CHANGE REQUEST

33.102 CR **xxx**   Current Version: **3.5.0**

Source:	Ericsson		**Date:**	2000-09-12

Subject:	Clarifications on the COUNT parameters.

Figure 16c: The structure of COUNT-C for all transmission modes

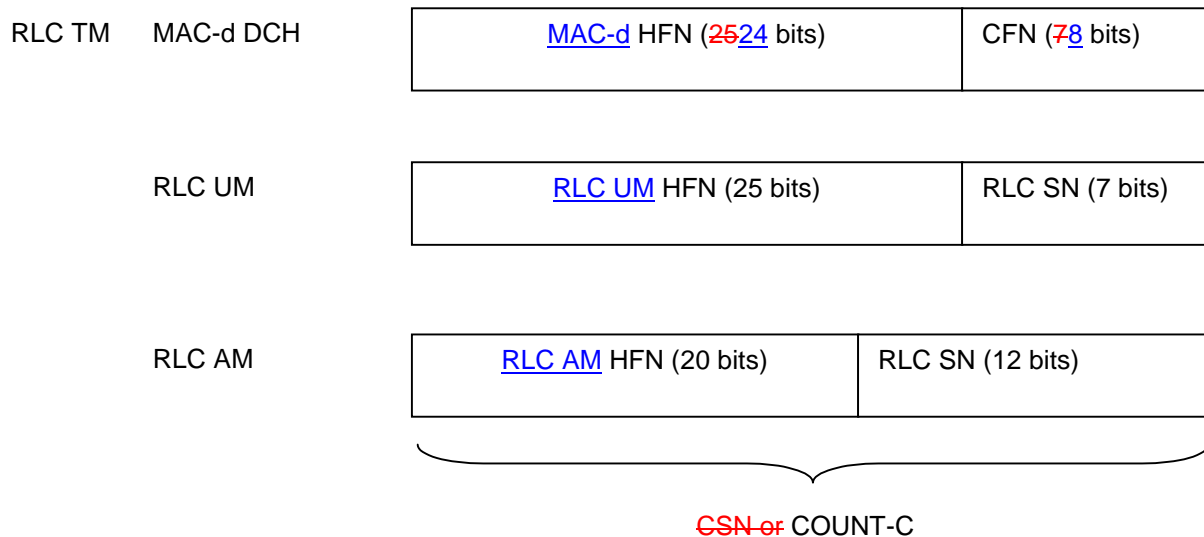
Reason for change:	Alignment with TS 25.331, TS 25.321 and TS 25.322 1. "UEFN" and "CSN" should be removed since these terms have no validity 2. There are separate UL/DL COUNT-I respective separate UL/DL COUNT-C per radio bearer. 3. The length of CFN is 8 bits and not 7 bits. 4. Definition of ciphering unit 5. Editorial modifications

| RLC TM | MAC-d DCH | MAC-d HFN (~~25~~24 bits) | CFN (~~7~~8 bits) |

- For RLC TM on DCH, the "short" sequence number is the ~~7-bit~~ 8-bit ~~ciphering~~connection frame number CFN of ~~the UEFN~~COUNT-C. It is independently maintained in the ME MAC-d entity and the SRNC MAC-d entity. The "long" sequence number is the ~~25~~24-bit MAC-d HFN, which is incremented at each CFN cycle. ~~The ciphering sequence number CSN or COUNT-C is identical to the UEFN.~~
